System Impact Assessment Report

Final Report

CAA ID: 2009-364
Project: Kitchener MTS #9
Applicant: Kitchener-Wilmot Hydro Inc.

Market Facilitation Department
Independent Electricity System Operator

Figure 1: Single Line Diagram of Kitchener MTS #9

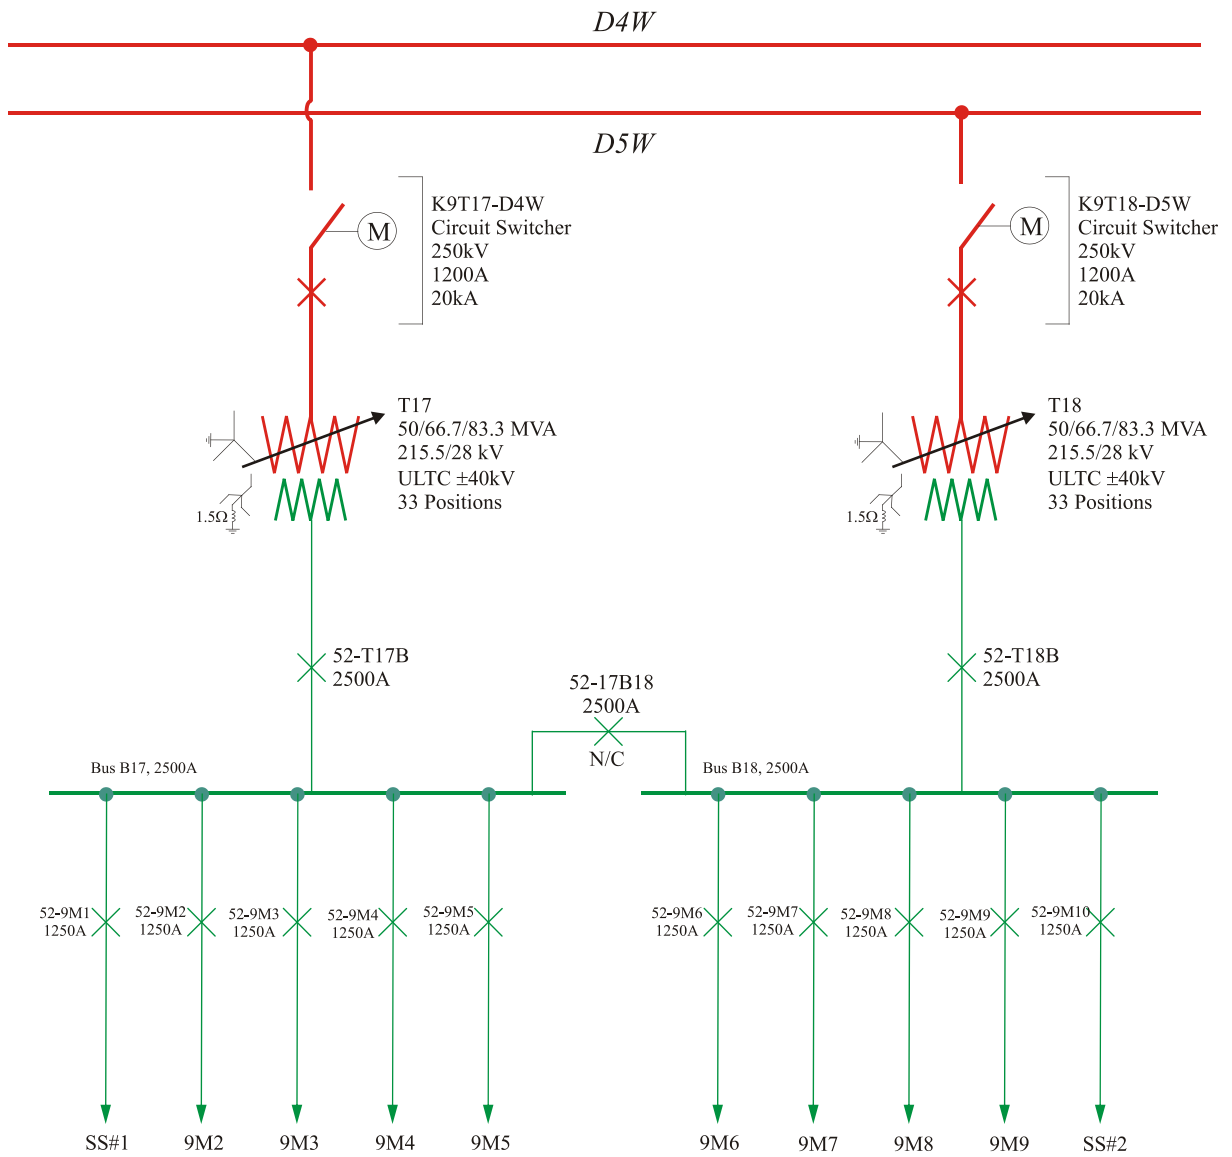
The Kitchener MTS #9 shown in Figure 1 will not reduce the level of reliability of the integrated power system and is, therefore, acceptable to the IESO.
